SUBJECT: ISSUANCE OF AMENDMENT NO. 116 TO FACILITY OPERATING LICENSE NO. NPF-12 REGARDING INCREASED LIMIT FOR FUEL ENRICHMENT - VIRGIL C. SUMMER NUCLEAR STATION, UNIT NO. 1 (TAC NO. M88452)

VIRGIL C. SUMMER NUCLEAR STATION, UNIT NO. 1

AMENDMENT TO FACILITY OPERATING LICENSE

SAFETY EVALUATION BY THE OFFICE OF NUCLEAR REACTOR REGULATION
RELATED TO AMENDMENT NO. 116 TO FACILITY OPERATING LICENSE NO. NPF-12

FIGURE 3.9-1 MINIMUM REQUIRED FUEL ASSEMBLY BURNUP AS A FUNCTION OF INITIAL ENRICHMENT TO PERMIT STORAGE IN REGION 2

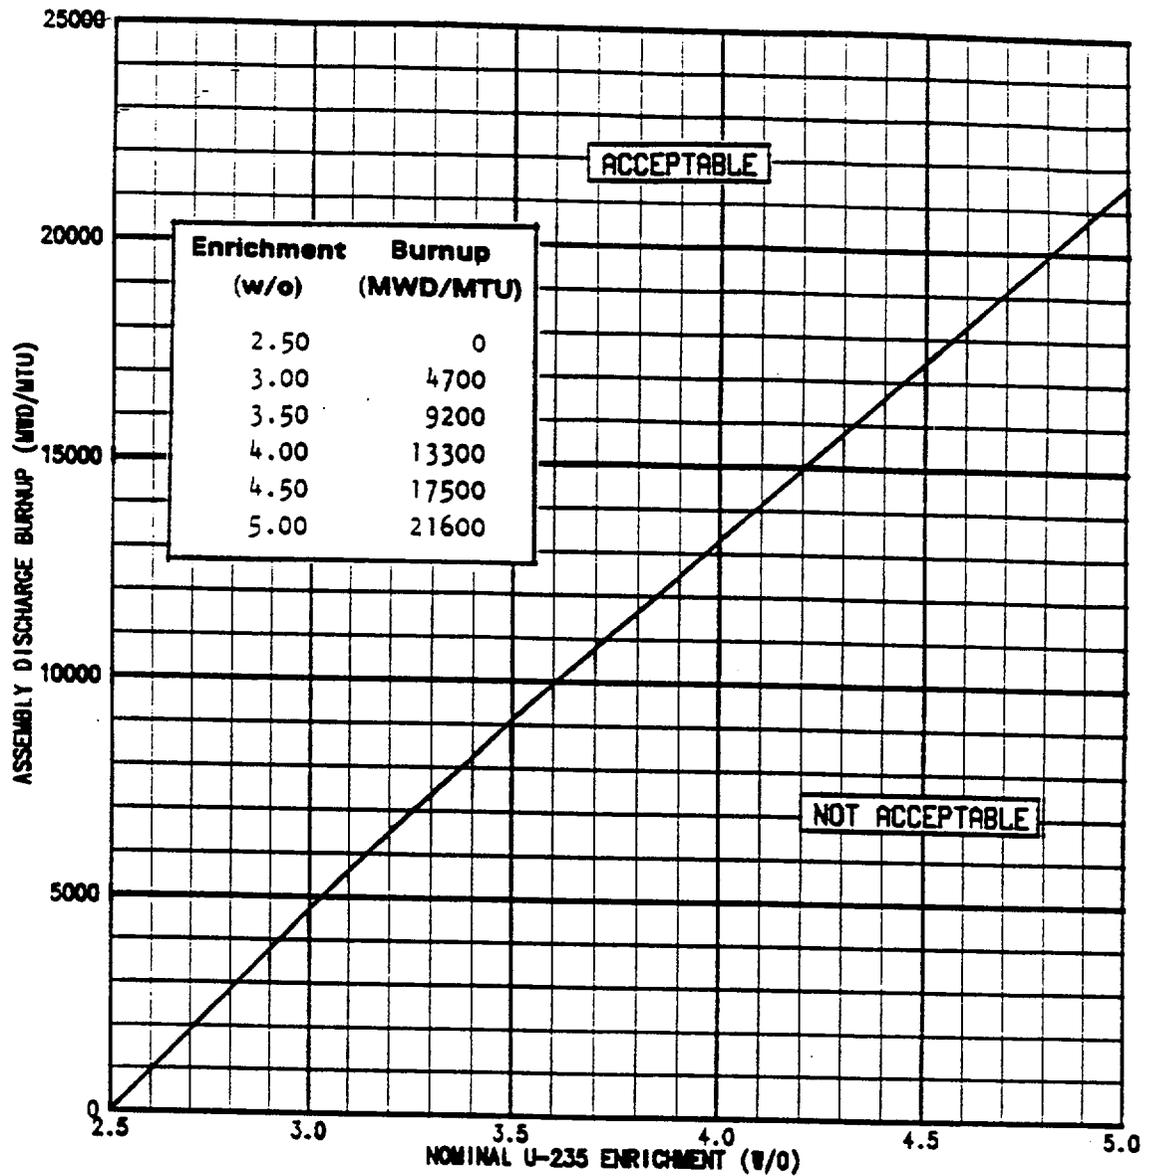
To enable the storage of fuel assemblies initially enriched to greater than 2.5 w/o U-235, the concept of burnup credit reactivity equivalencing was used. This is predicated upon the reactivity decrease associated with fuel depletion and has been previously accepted by the staff for spent fuel storage analysis. For burnup credit, a series of reactivity calculations are performed to generate a set of initial enrichment-fuel assembly discharge burnup ordered pairs which all yield an equivalent k_{eff} less than 0.95 when stored in the spent fuel storage racks. This is shown in Figure 3.9-1 in which a fresh 2.5 w/o enriched fuel assembly yields the same rack reactivity as an initially enriched 5.0 w/o assembly depleted to 21,600 MWD/MTU. This curve includes a reactivity uncertainty of 0.0072 due to depletion calculations.

- (1) Figure 3.9-1 has been revised to place restrictions on fuel burnup as a function of initial enrichment up to 5.0 w/o U-235 and to account for the effects of Boraflex panel shrinkage and gaps in Region 2 of the spent fuel pool.

2. A maximum nominal enrichment of 2.5 weight percent U-235 with no burnup and up to 5.0 weight percent U-235 with a minimum burnup of up to 21,600 MWD/MTU, as specified in Figure 3.9-1.

FIGURE 3.9-2 MINIMUM REQUIRED FUEL ASSEMBLY BURNUP AS A FUNCTION OF INITIAL ENRICHMENT TO PERMIT STORAGE IN REGION 3

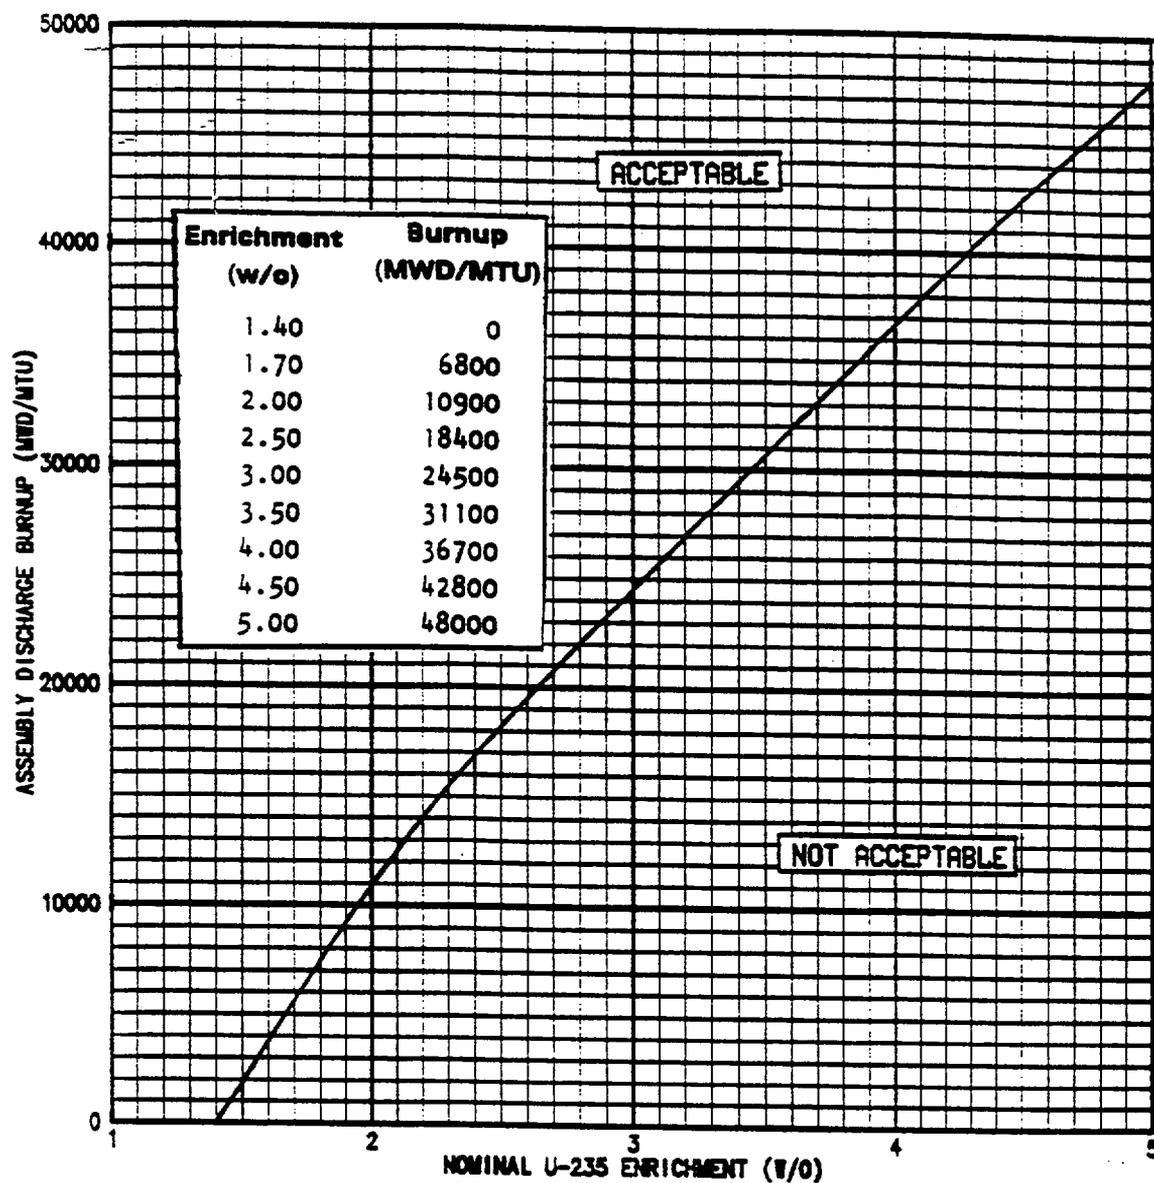
As for Region 2, burnup credit reactivity equivalencing was used to allow storage of fuel assemblies with initial enrichments greater than 1.4 w/o U-235. Figure 3.9-2 shows that fresh 1.4 w/o enriched fuel is equivalent to initially enriched 5.0 w/o fuel which has achieved a burnup of 48,000 MWD/MTU. The curve includes a reactivity uncertainty of 0.0160 due to depletion calculations.

- (2) Figure 3.9-2 has been revised to place restrictions on fuel burnup as a function of initial enrichment up to 5.0 w/o U-235 in Region 3 of the spent fuel pool. Region 3 does not contain Boraflex.

2. A maximum nominal enrichment of 1.4 weight percent U-235 with no burnup and up to 5.0 weight percent U-235 with a minimum burnup of up to 48,000 MWD/MTU, as specified in Figure 3.9-2.
